STATE OF OHIO
DEPARTMENT OF TRANSPORTATION
MAH-680-4.58
PART 1
CITY OF YOUNGSTOWN
MAHONING COUNTY
FOR PART 2 SEE MAH-680-4.58

FEDERAL PROJECT NUMBER
E250327
RAILROAD INVOLVEMENT
NONE
PROJECT DESCRIPTION
THE PROJECT CONSISTS OF FULL DEPTH PAVEMENT REPLACEMENT OF MAHONING I.R. 680 FROM THE S.R. 193 INTERCHANGE (SLM-4.58) TO SOUTH OF THE SOUTH AVENUE INTERCHANGE (SLM-7.37), ALL INTERCHANGE RAMPS WITHIN THE CORRIDOR WILL BE RECONSTRUCTED, INCLUDING RAMPS TO AND FROM S.R. 193 AND U.S. 62/S.R. 7. INCLUDES BRIDGE WORK TO MAH-680-4.886 (SFN 5006872). THIS PROJECT ALSO INCLUDES THE REMOVAL OF THE MAHONING AVENUE ENTRANCE RAMP TO I.R. 680 SOUTHBOUND.
ADDITIONAL WORK INCLUDES GUARDRAIL AND CONCRETE BARRIER REPLACEMENT, ROADWAY DRAINAGE IMPROVEMENTS, SIDEWALK, CURB RAMPS, SIGNING, LIGHTING AND PAVEMENT MARKINGS.

R3 01-13-2026, SUPPLEMENTAL SPECIFICATIONS 813 AND 913 ADDED

CROSS SECTIONS - I.R. 680
 STA. 1026+00.00 TO STA. 1031+00.00

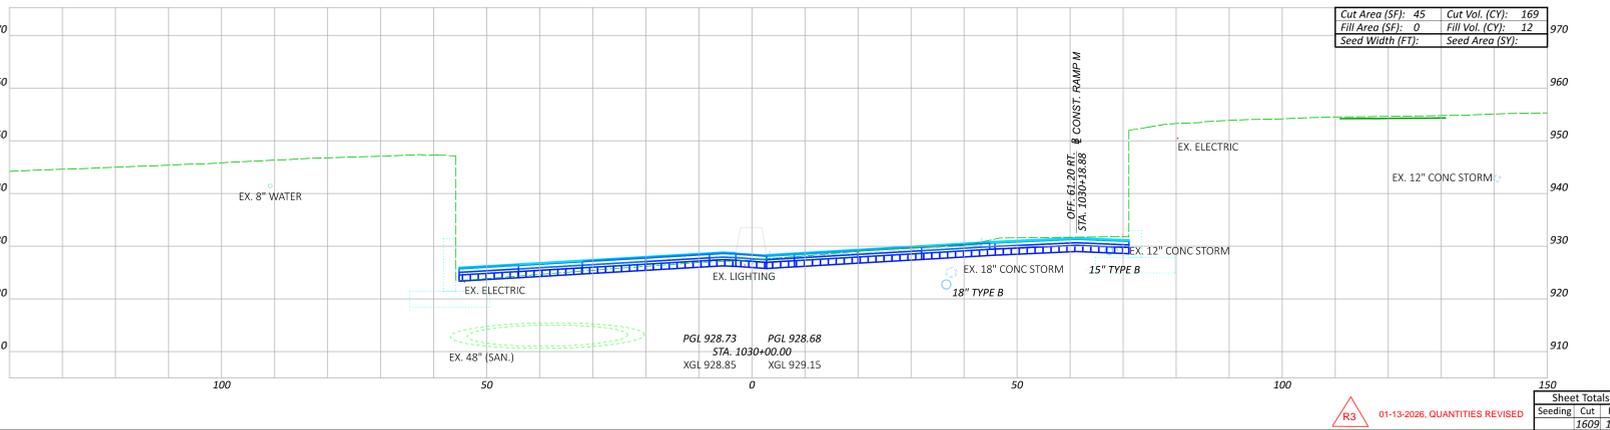
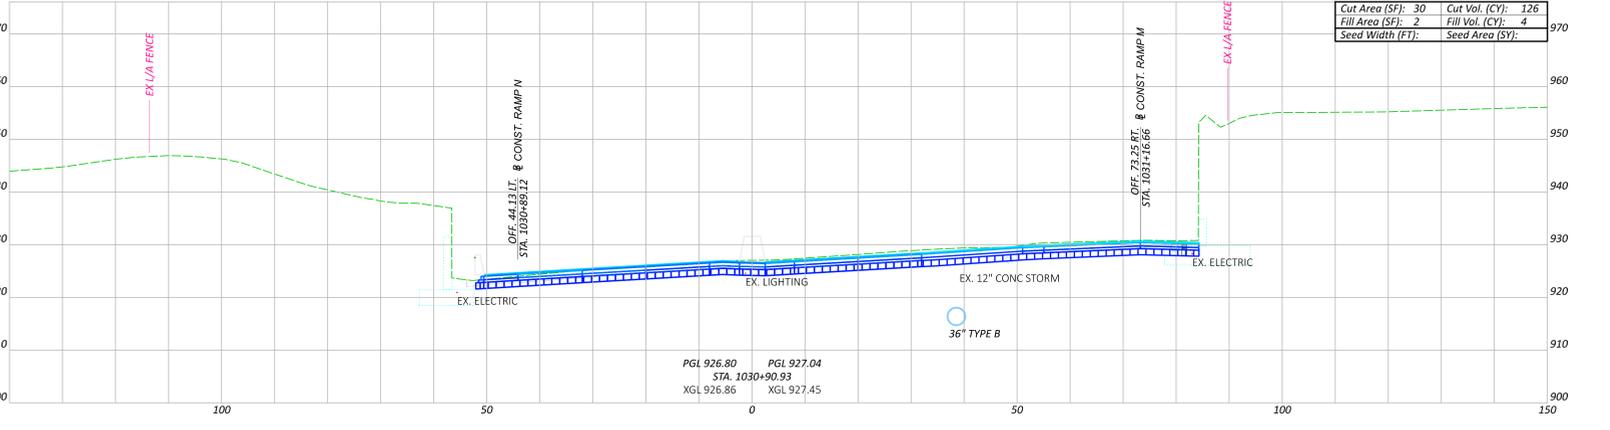
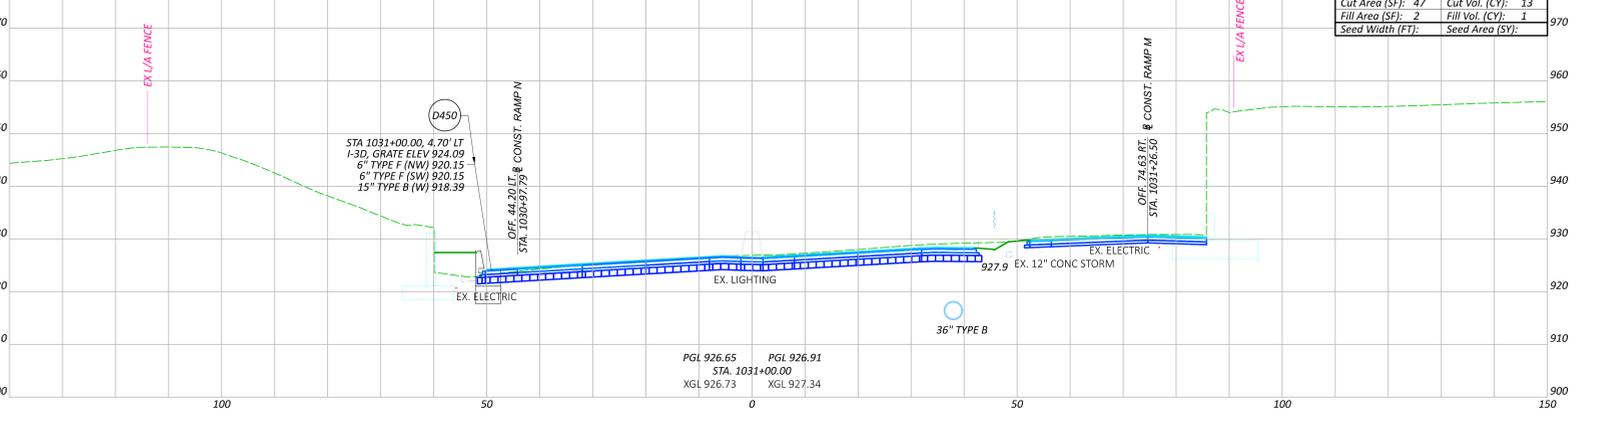
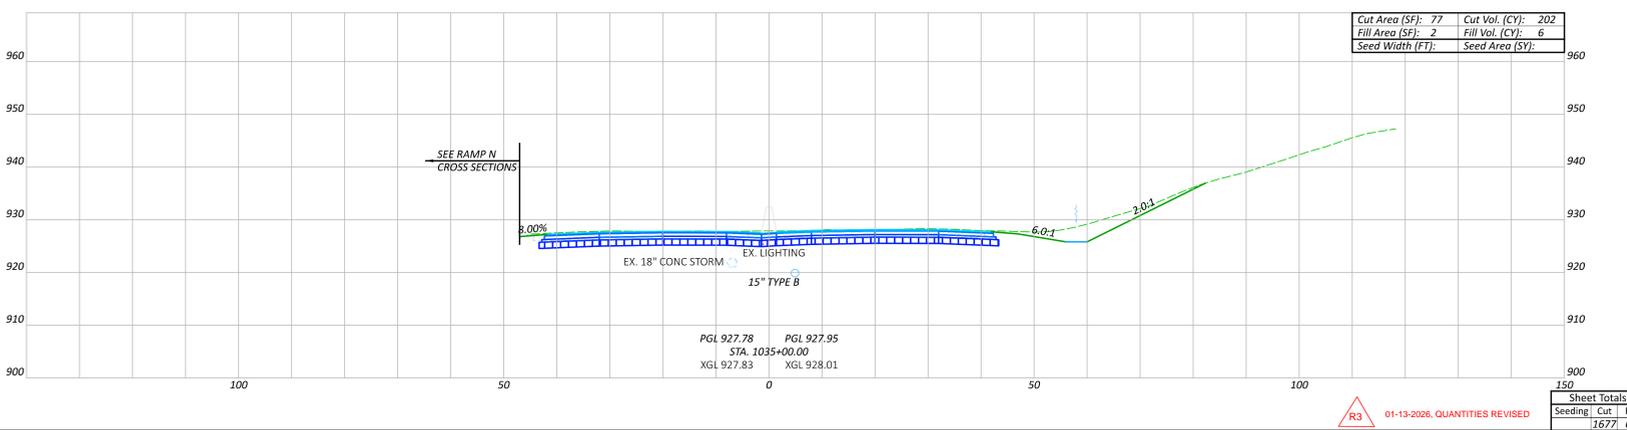
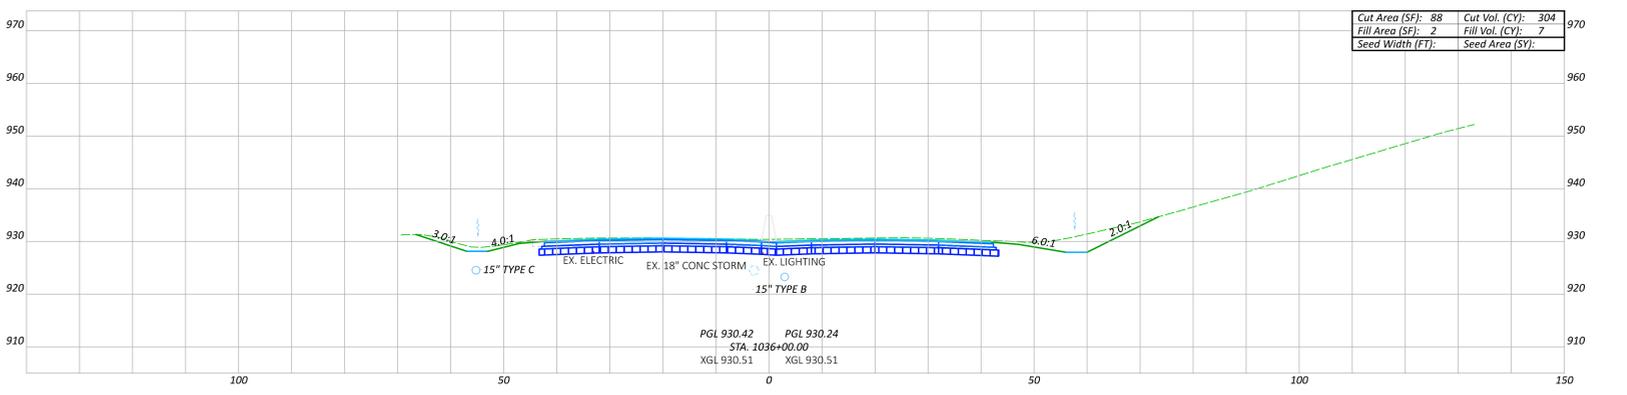
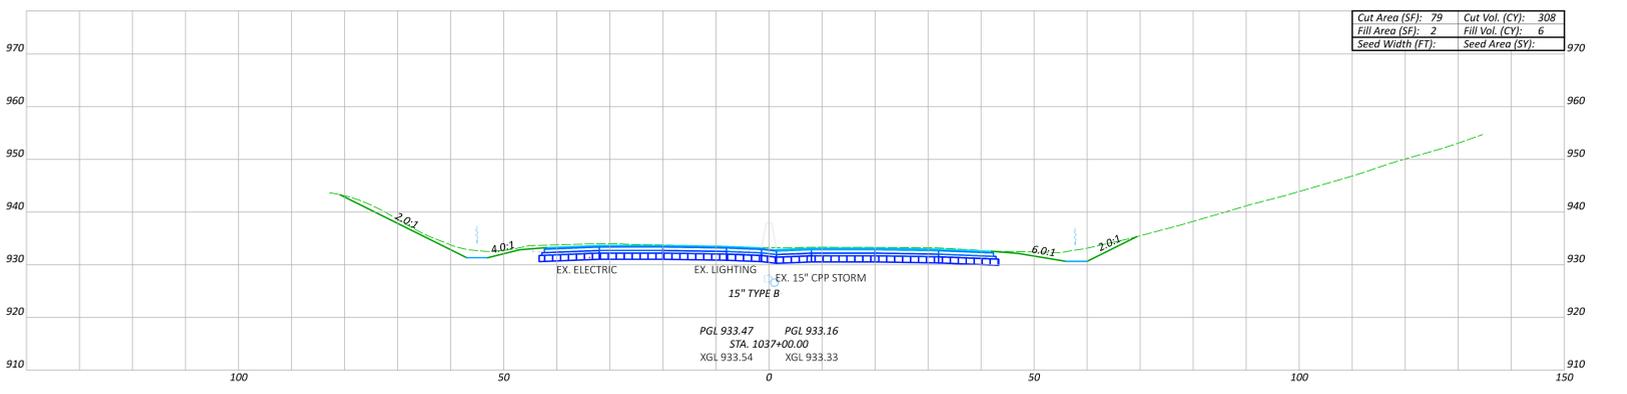
CONSULTANTS INC.
 DESIGNER
 MSN
 REVIEWER
 CMN 08/29/25
 PROJECT ID
 121474
 SHEET TOTAL
 1609 / 113
 P. 278 / 655
 01-13-2026, QUANTITIES REVISED

CROSS SECTIONS - I.R. 680
 STA. 1070+00.00 TO STA. 1076+00.00

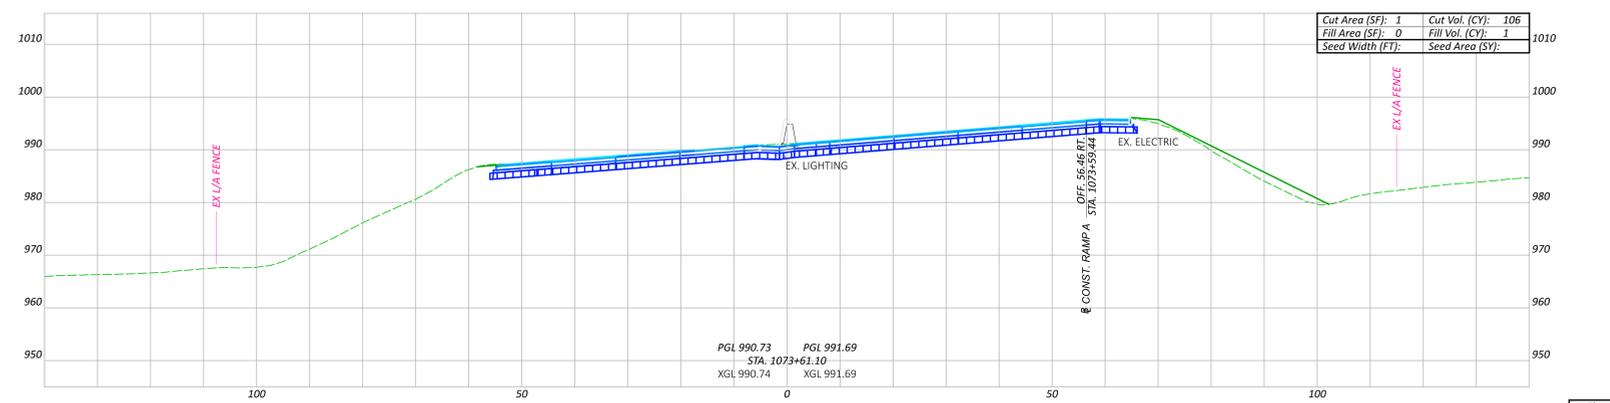
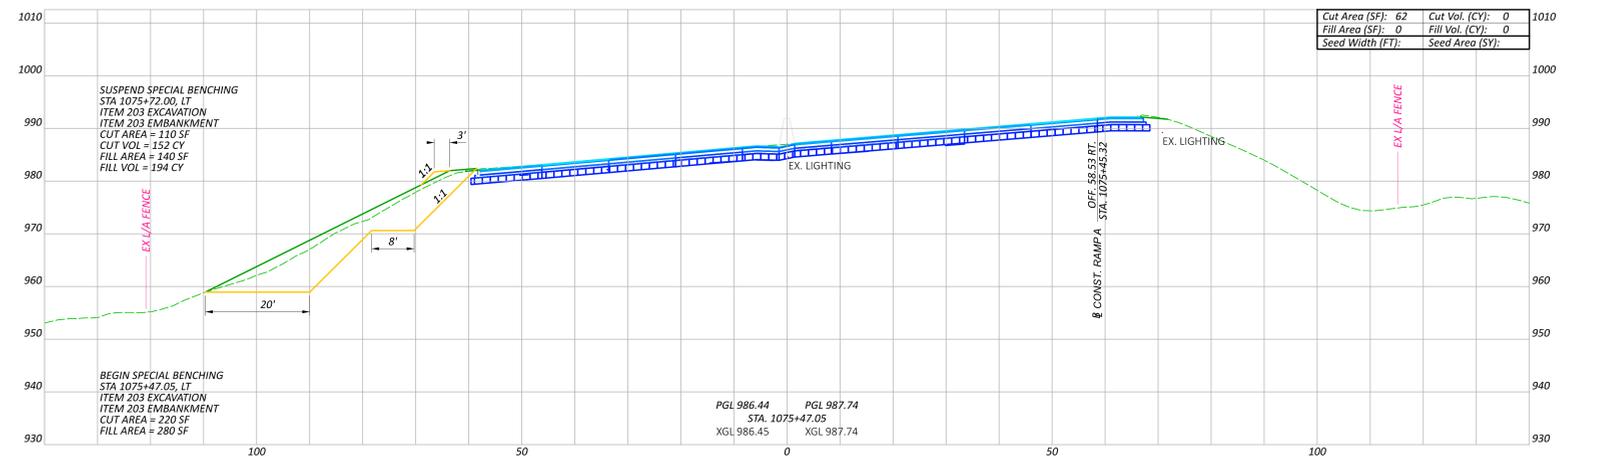
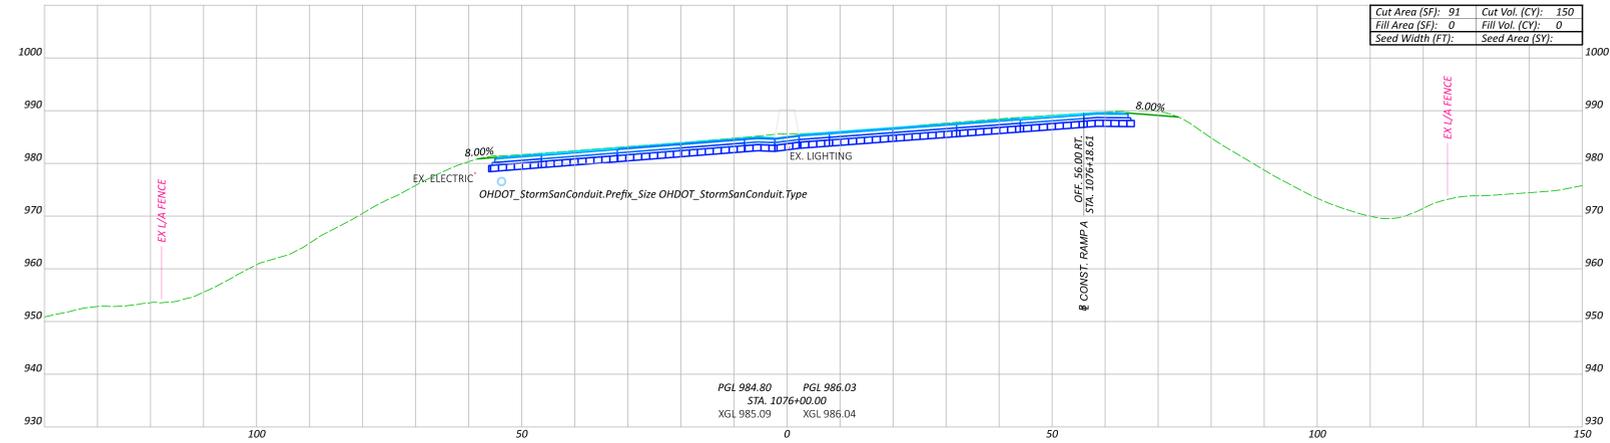
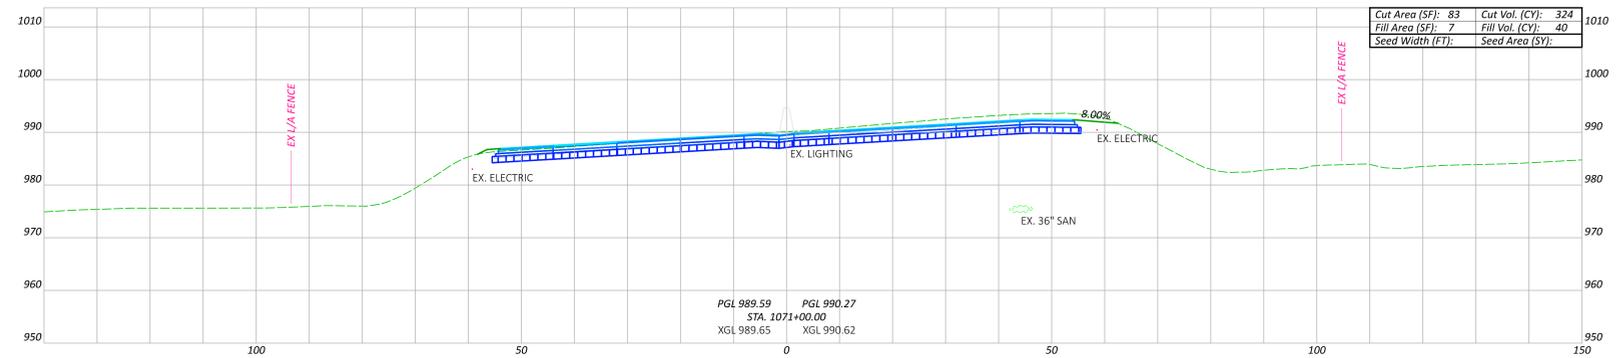
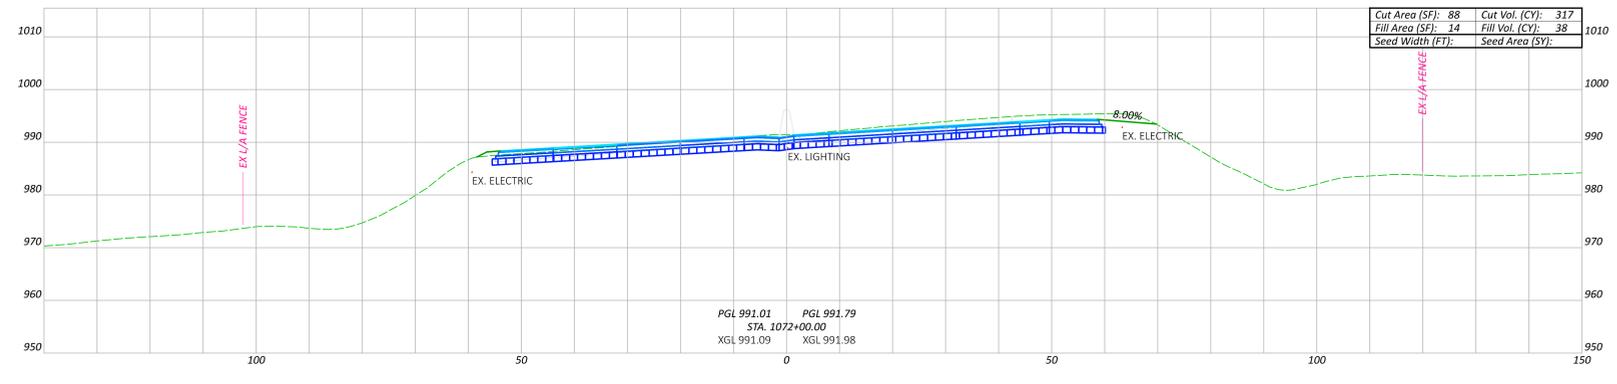
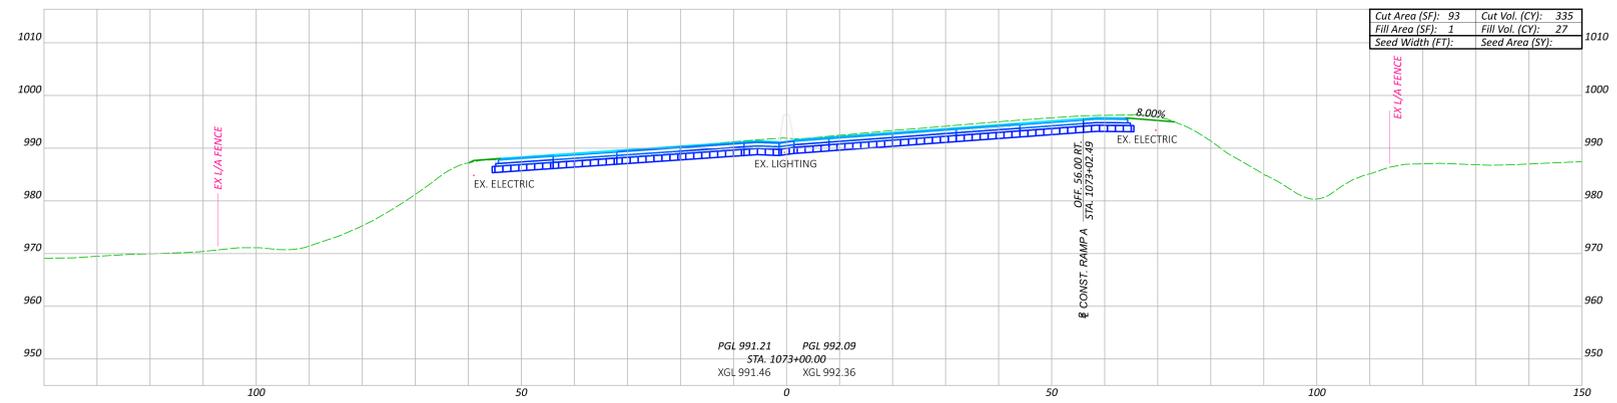
01-13-2026, QUANTITIES REVISED
